**Request**  
**Project Name**  
**Council District**  
**Requested by**

**DTC Modification**  
**13<sup>th</sup> & McGavock**  
19 – O’Connell  
Rajesh Aggarwal, with McGavock Street Partnership  
Lesley Beeman, Jr., AIA, with Manuel Zeitlin Architects

## Downtown Code DRC Meeting of 1/4/2016

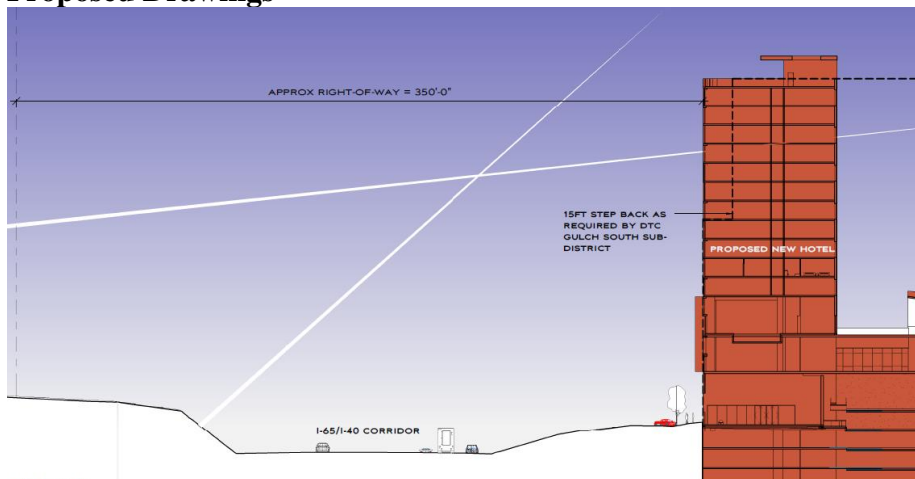
Planning staff studied the relationship of the proposed building height, setback, and stepback conditions and the adjacent right-of-way width to determine how the design affects the availability of light and air onto the street. Along the western face of the building, the combined right-of-ways of 13<sup>th</sup> Avenue North, I-40/I-65, and 14<sup>th</sup> Avenue South equate to a distance of greater than 350 ft. Given the excessive distance between the face of buildings on opposite sides of the I-40/I-65 corridor, the impact from relief of the required stepback seems negligible.

In general, the massing of the building helps to create a specific urban character through its built form, which is consistent with the goals of the DTC. More specifically, the proposed L-shaped

configuration of the building holds the corner and maintains a well-defined street edge. Furthermore, the proposed configuration offers to line the parking structure along the ground and upper levels so that the parking is tucked away from the public right-of-way and out of the view of the pedestrian eye. In turn, the proposed garage liner offers a building that prioritizes and interacts with the public realm along the ground and upper levels. Finally, the overall composition of massing components appears integrated as one whole form.
